Permit Type	Permit Number	Opened Date
Building/Residential/Garage/Detached	B26000607	03/02/2026
Description of Work		
SFD/ CONSTRUCT PRE-FAB 20' X 36' METAL GARAGE, 1 STORY, Slab on Grade, 1R, 0FB, 0HB, 0FP, OTHER STRUCTURE = Detached Garage, 0BR, PORCH/DECK = N/A, ENERGY METHOD = N/A,

APPLICATION FOR VARIANCE
TO COMAR ONSITE WATER/SEWER FOR MDE APPROVAL

Active permit for detached garage - No. B26000607

OWNER: Robert Girdi PHONE #: \_\_\_\_\_  
ADDRESS: 3785 Woodbine CONTRACTOR: \_\_\_\_\_  
WELL TAG #: HO-88-1660  
SUBDIVISION: \_\_\_\_\_ LOT: \_\_\_\_\_ COUNTY #: \_\_\_\_\_  
PROPOSAL: Garage on foundation in the rear of  
the property

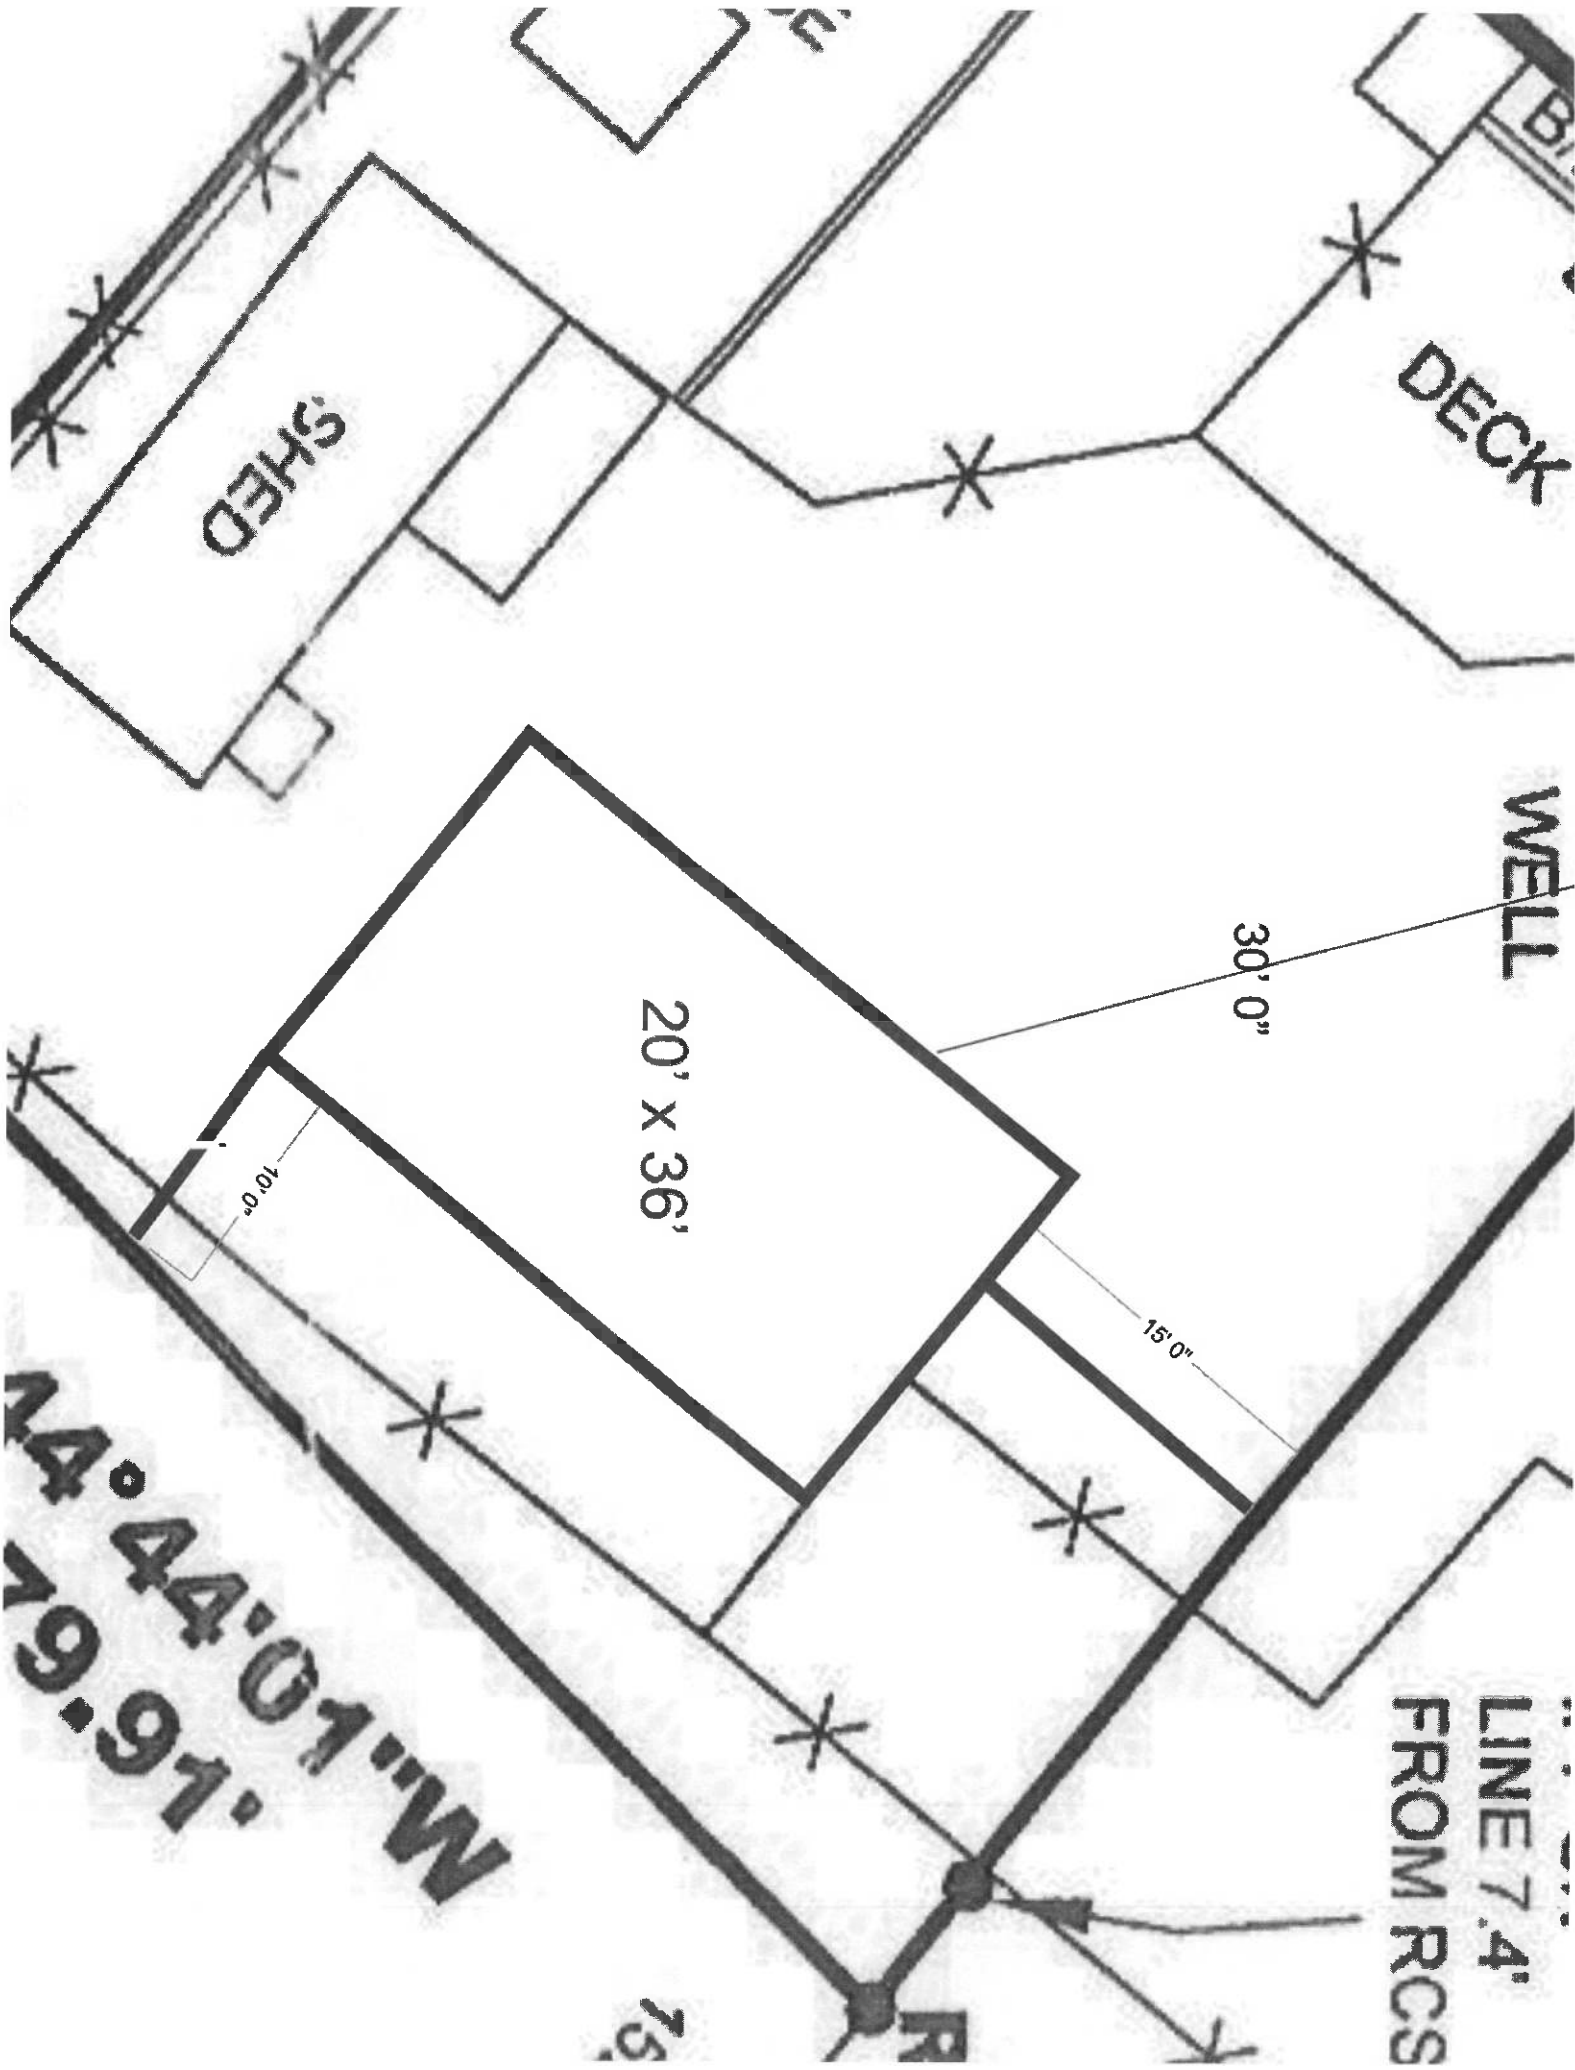
- Regulation Section Summary and Explanation
1. COMAR 26.04.04.04 2). A proposed well location for a water supply or open loop g... (c)30 feet from a building foundation.
2. I am requesting a variance for 27' to 28' from well for better spacing from existing fence line in order to have room to make a proper retaining wall on the high side of the foundation.

Please see the attached variance that we spoke about regarding a setback reduction to your well. You will need to fill in the description of your request for the setback reduction (provide distance in ft.) to the proposed garage and details of your project proposal. Also, as discussed we need a scaled plan showing the distance to your well and the survey plan I determined was at a scale of 1"= 40' (printed on 8.5X11") and would be the best plot plan to use for this purpose. Let me know if you have any other questions or need further assistance in this process and I will be happy to help. When I have further information on the 1-3' setback reduction from my supervisor I will certainly let you know. Hope you have a nice weekend and thank you kindly.

Reviewed by: HCHD Staff, Date: 4/24/26
Recommendation: [X] Recommended [ ] Not Recommended
HCHD Supervisor, Date: 4/29/26
